Ashton Coal Project – proposed South East Open Cut Project

RE: South East Open Cut Project – Response to OEH letter to the PAC dated 17 August 2012

RE: South East Open Cut Project – Response to NOW letter to the PAC dated 9 July 2012

Plate 1 – Flood Frequency Analysis for Glennies Creek at the Middle Falbrook Stream Gauge.

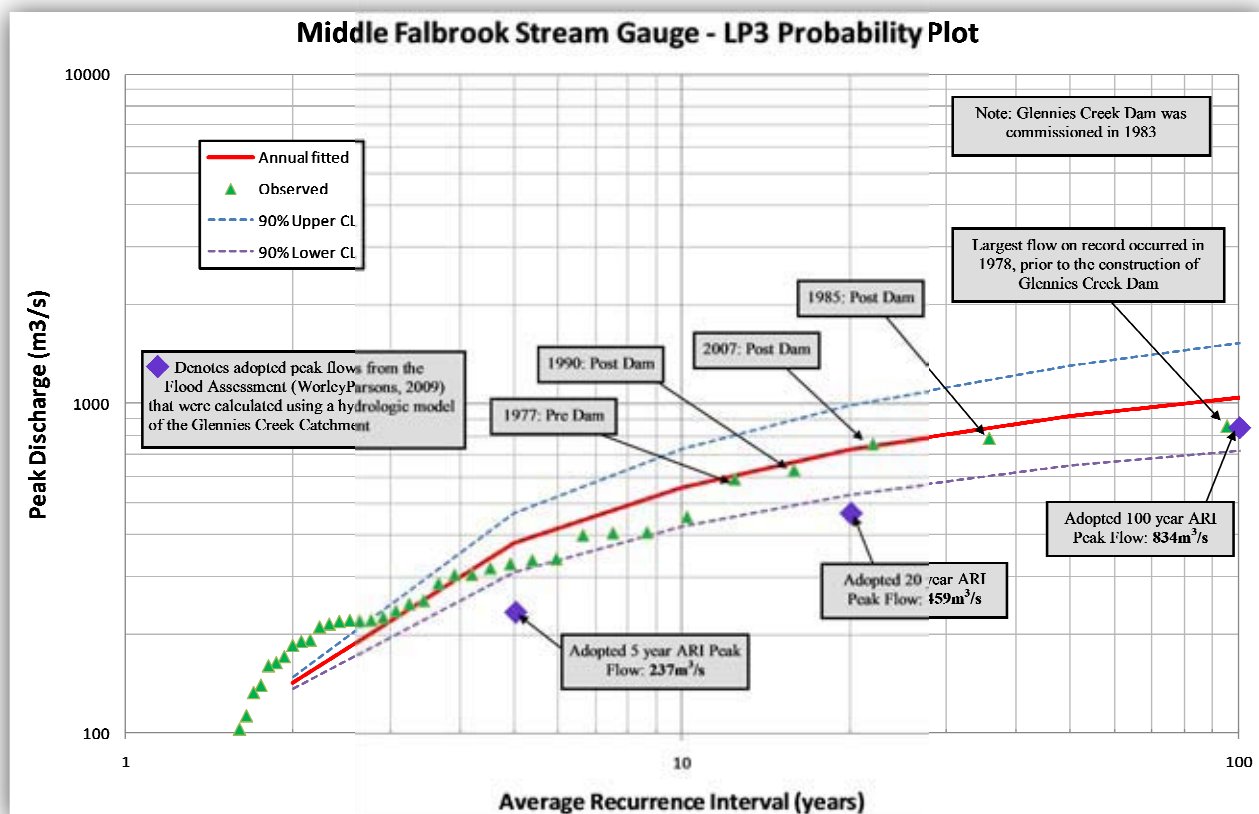
In order to verify the hydrologic modelling results, SMEC has undertaken further hydrologic assessment of the Glennies Creek Catchment using flood frequency analysis techniques. Flood frequency analysis is recognised in Australian Rainfall and Runoff (AR&R, 1987)⁷ as one of the available methods for estimating the magnitude and frequency of peak flood discharges.

With reference to **Plate 1**, peak flows calculated from flood frequency analysis were 25% higher than peak flows calculated using the hydrologic model for the 100 year ARI event and 55 to 60% higher for the 5 and 20 year ARI events. **Table 1** compares the results from the two methods.

Plate 2 – Water surface profiles for a full range of flood events using the peak flows calculated from the hydrologic model (in purple) and flood frequency analysis (in blue).

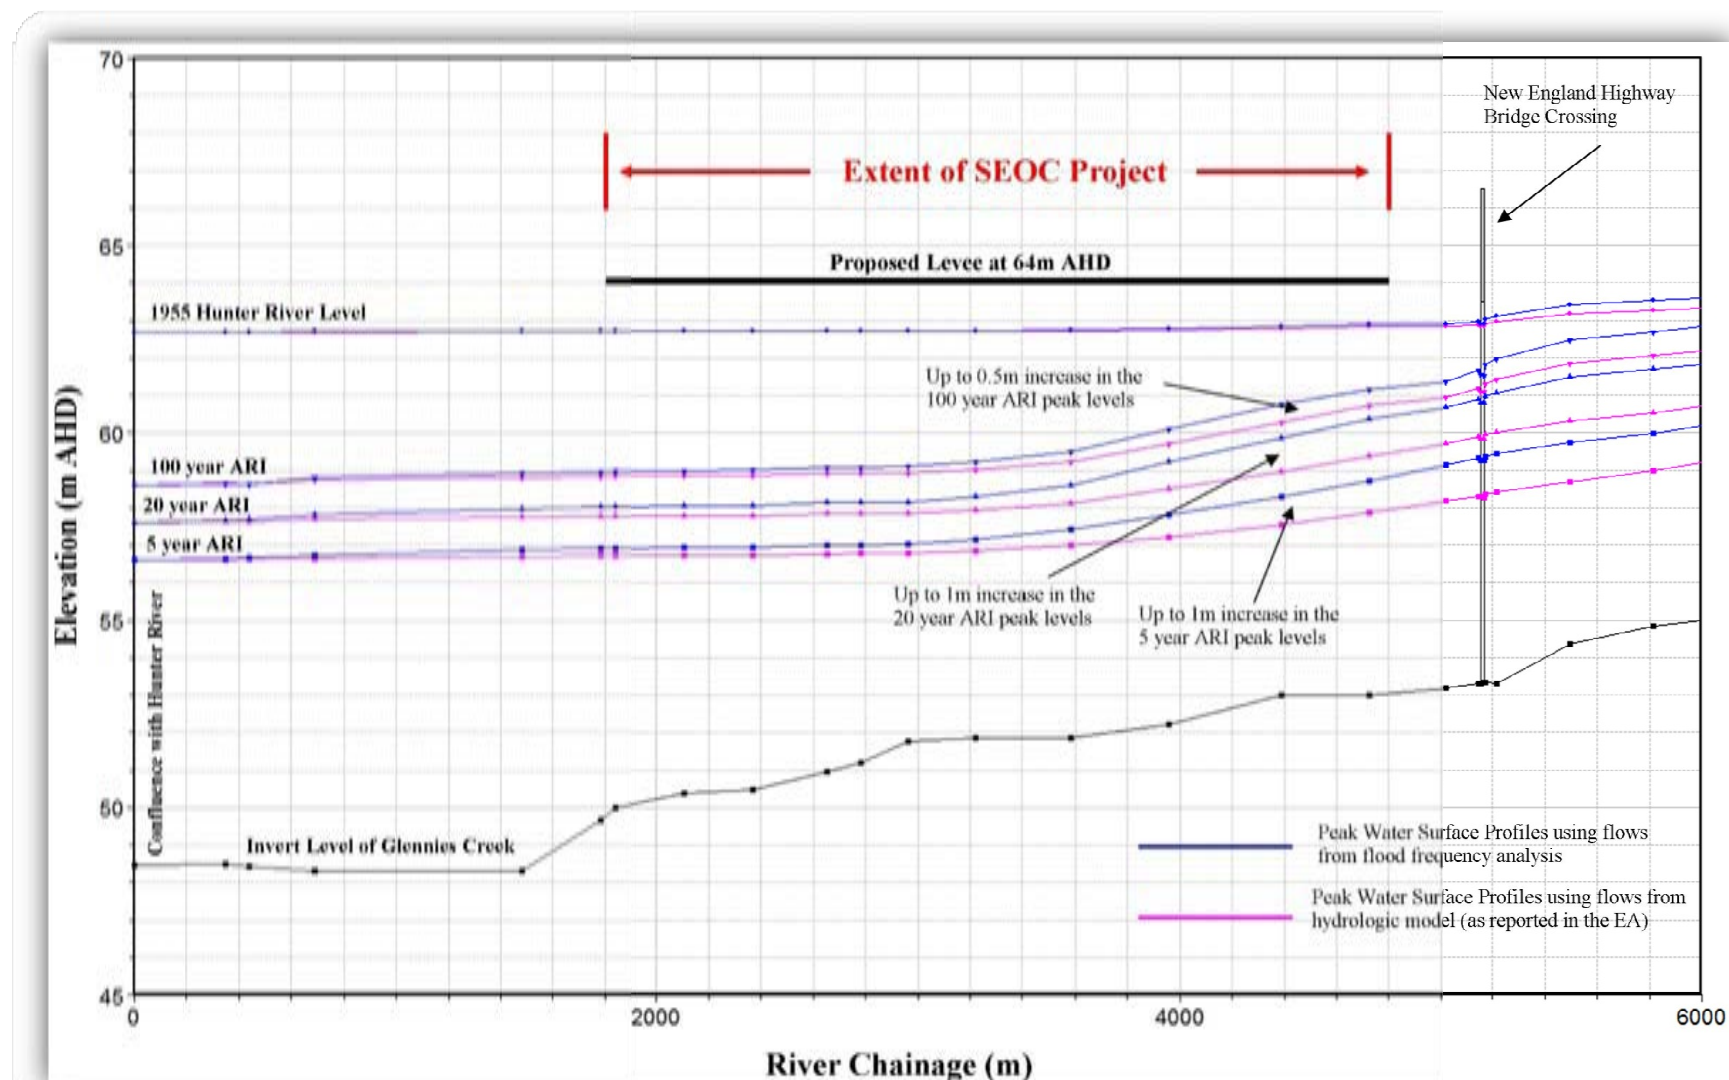
Notwithstanding the above discussion, sensitivity analysis was undertaken to determine the impact of the higher peak flows calculated using flood frequency analysis methods on the hydraulic model results that were reported in the Flood Assessment (WorleyParsons, 2009). This analysis was undertaken by running additional HEC-RAS simulations using the peak flows derived from flood frequency analysis that are reported in **Table 1**. The results from this analysis are presented in the following formats:

- **Plate 2** plots the predicted peak water surface profiles for a full range of flood events using the peak flows calculated from the hydrologic model (in purple) and flood frequency analysis (in blue).
- **Table 2** compares the key flood characteristics (flood level and velocity) for the 100 year ARI event using the two peak flow scenarios. Results are reported for all cross-sections between river chainage 1785 m (downstream extent of the project area) and 5149 m (New England Highway Bridge). Note the proposed levee extends up to river chainage 4389 m. Refer to **Attachment 1** for cross-section locations.

As demonstrated in **Plate 2**, the higher Glennies Creek water surface profile is more than 2 m below the 1955 Hunter River flood level (62.7 m AHD), which has been adopted as the flood planning level for the project. Accordingly, increasing the assumed peak flows in Glennies Creek would not result in any material change to the outcomes of the flood study.

Plate 3 – Key flood conveyance areas within the Glennies Creek Floodplain. Note: image has been sourced from Figure 11 from the Flood Assessment (WorleyParsons, 2009).

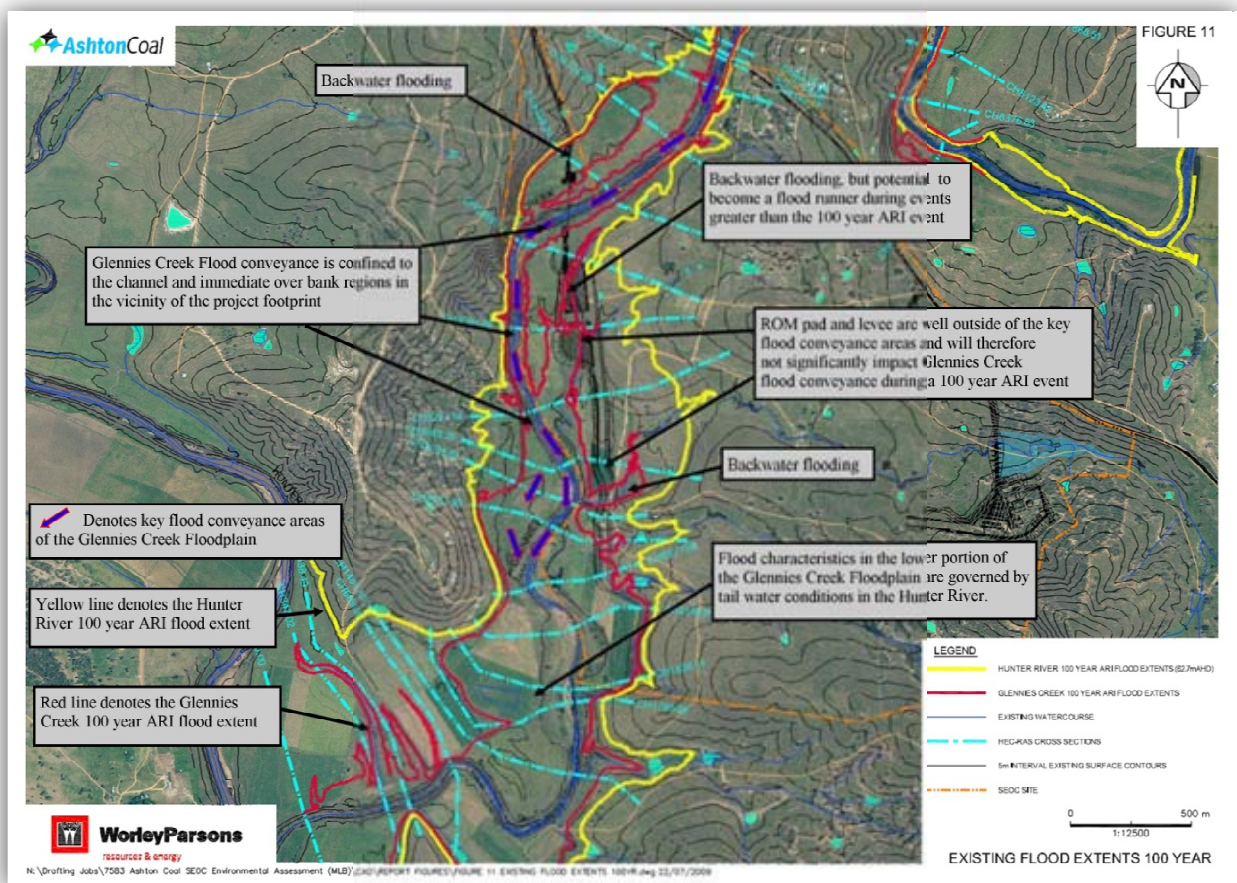
SMEC Response (Issue 2) – Results from the one-dimensional HEC-RAS model indicate that flow conveyance during a Glennies Creek 100 year ARI flood event will be primarily confined to the river channel and immediate overbank areas. This is demonstrated in **Plate 3**, which shows that the Glennies Creek flood extent (indicated by the red line) within the project area is primarily confined to the channel and immediate overbank regions. The exception to this is where the inundation extends up the numerous creek gullies that flow into Glennies Creek within the project area (noted as back water flooding in **Plate 3**). Flooding within these gullies occurs due to backwater flooding from the creek channel. Accordingly, minimal flow conveyance would occur in these areas of the floodplain.

As the flow conveyance during a Glennies Creek 100 year ARI flood event will be primarily confined to the river channel and immediate overbank areas, the flood hydraulics can be reliably represented in a one-dimensional hydraulic model, such as HEC-RAS. A more sophisticated two-dimensional model would be warranted if significant out-of-channel flow conveyance occurred within the project area.

In SMEC's view, the application of a more sophisticated two-dimensional flood model will not change the outcomes of the Flood Assessment (WorleyParsons, 2009).

Attachment 1 –Section Drawings of the Final Void

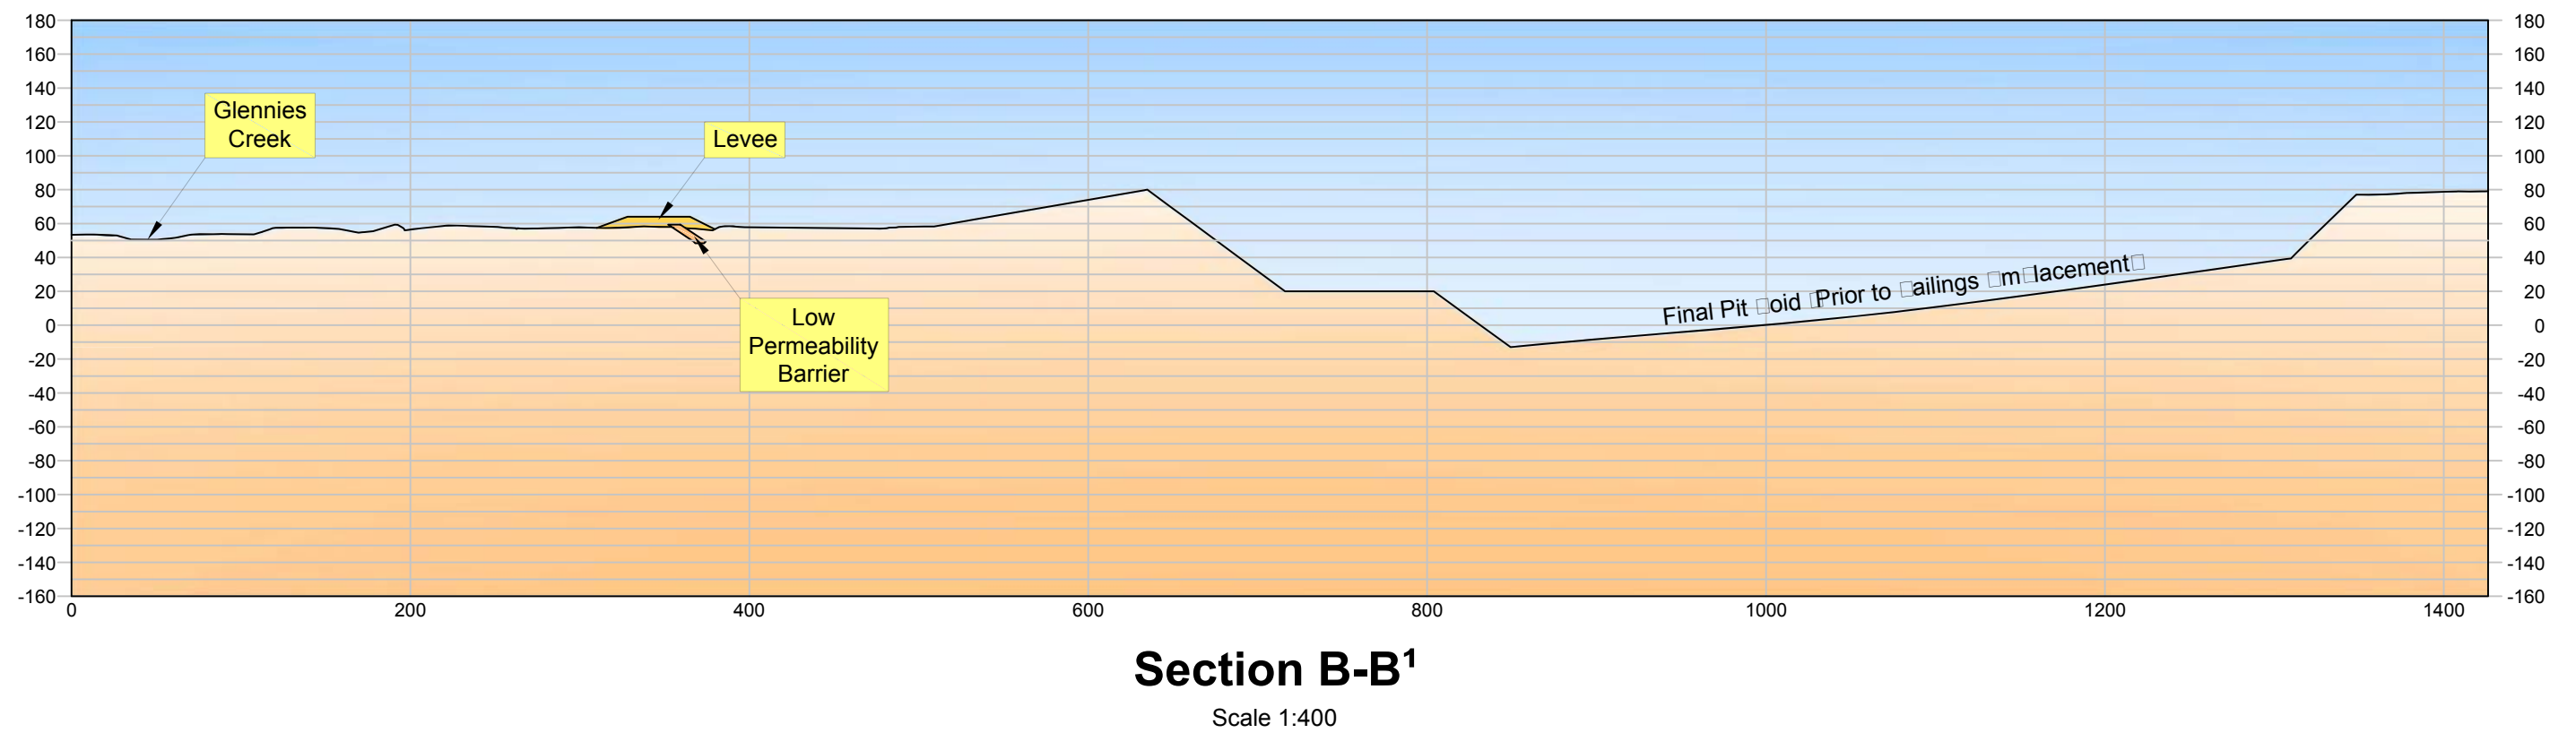
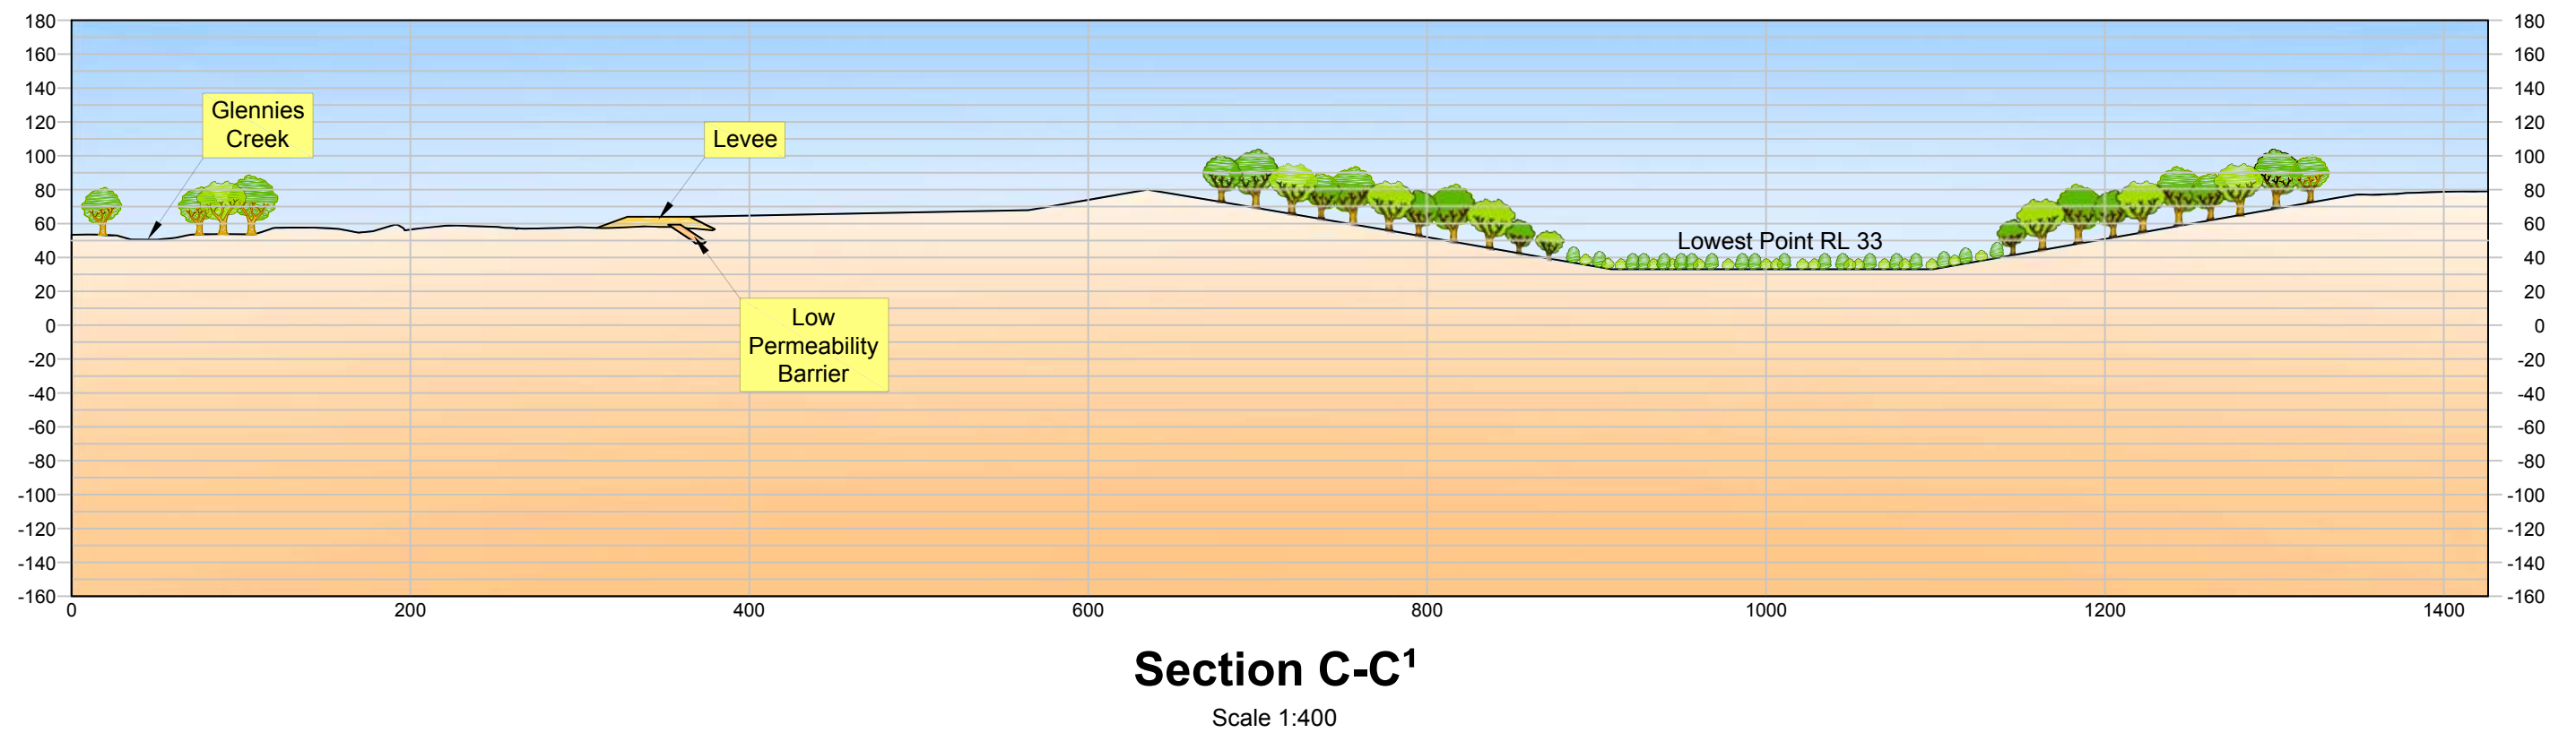
SMEC Response – This analysis is technically incorrect as it is based on the reported PMF levels at the project for a Glennies Creek flood event, and does not consider PMF levels from a Hunter River flood event. As discussed in Section 1 of this response letter, flood levels at the project are governed by backwater flooding from the Hunter River. This will certainly be the case for the PMF. Hence, for a levee to achieve a PMF level of flood protection, it would need to be constructed to the Hunter River PMF level. The Hunter River PMF level was not estimated as part of the Flood Assessment as any flood that results in the levee overtopping would have the same consequence (i.e. inundation of the pit). Hence, the flood risk to the pit can be reliably estimated based on the design level of flood protection. As discussed in Section 2 of this response letter, the proposed flood levee would provide a greater than 150 year ARI level of flood protection, which in SEMC's view, provides an appropriate level of flood risk mitigation.

ACOL have revised the final landform to accommodate a berm that will be built to 80m AHD (refer to Attachment 1 for section drawings). This berm will be constructed between the final void and Glennies Creek and will effectively prevent the ingress of flood waters into the final void under any conceivable event, including a Glennies Creek Dam Break event. Hence, it can be concluded that there is no risk that floodwaters will enter the final void following mine closure. This effectively manages the long term flood risk profile of the final landform design.
